Planning Application 2024/62/92444/E – Land North of Denby Lane, Denby Lane, Grange Moor, Huddersfield, WF4 4BH (Erection of 21 dwellings and associated works with means of access from Denby Lane)

I refer to my previous correspondence dated 26 November 2024 and 13 February 2025 with respect to the above. I note the recent submission of a revised layout plan reference “Site Plan Rev U” and would add the following comments to those already set out in my earlier letters.

Extract of submitted plan Rev U

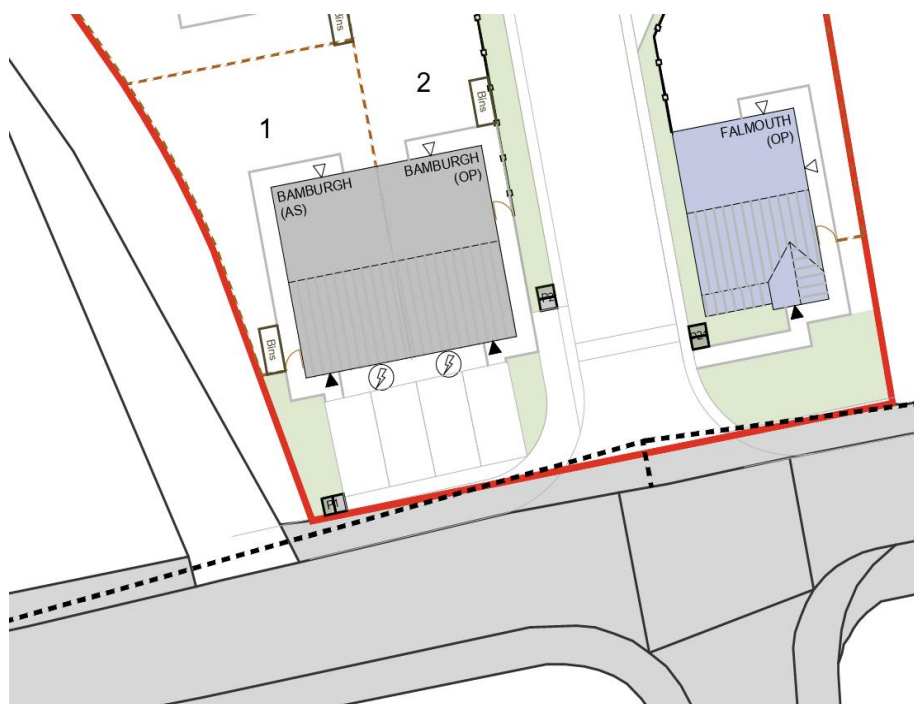
The indicated sight line is not set out on the central axis of the junction and is more to the west. This has a knock-on effect on the impact of the sight line on my adjoining land and is a matter that I have consistently brought to your attention throughout my correspondence on both this and the previous application for development of this site.

It is therefore important that this point is reviewed, and the sight line correctly imposed to demonstrate that the correct level of vision can be achieved without third party land. In addition, a revised series of vehicle swept path analysis are required to show that the amended junction operates correctly for vehicle movements in all directions.
